**Assessment of Eight (8) Protected-Size Trees
at and adjacent to
17294 Wedgewood
Los Gatos, California**

Prepared for:
Mr. Sean Mullin, Associate Planner
Town of Los Gatos Community Development Department
110 E. Main Street
Los Gatos, CA 95030

Report by CTA
9/9/2021

The CTA marked up the applicant's sheet A-1.0 site plan dated March, 2021 by Lazari Design of San Jose, California as the basis for the tree location map markup on the following page of this CTA arborist report.

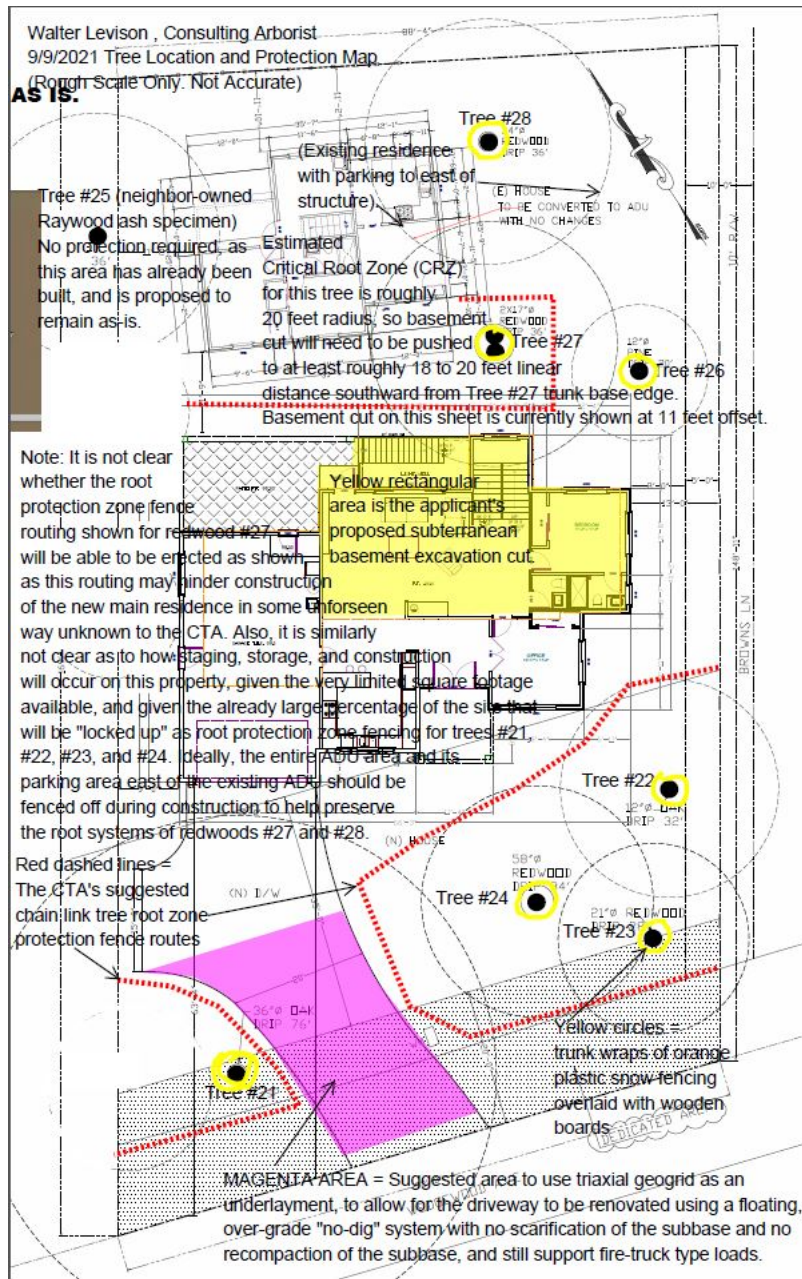
- a. Trunk plot dots are enlarged as black circles.
- b. (Tree canopies were already indicated by the architect, and are somewhat accurate in terms of true scale radius and diameter).

- c. Yellow highlighting indicates the applicant's proposed subterranean basement excavation cut daylights (farthest extent). The applicant has expressed to the CTA during his field visit that a 3rd round submittal set has been sent to Town of Los Gatos, showing a farther offset distance between redwood #27 edge of trunk massing, and the proposed garage limit of excavation, such that the new limit of excavation is roughly 18 linear feet from the trunk base edge (i.e. roughly the Critical Root Zone offset distance from trunk edge), which is good.

- d. Magenta highlight indicates the author's approximate proposed area where triaxial geogrid should be laid down over the soil surface to provide increased load capacity and allow for what is known as a "no dig" (floating) type driveway design where the entire set of layered materials is literally built up over existing soil grade elevation, avoiding excavation and avoiding subbase scarification and recompaction, which will help preserve and protect tree roots extended from redwood #27.
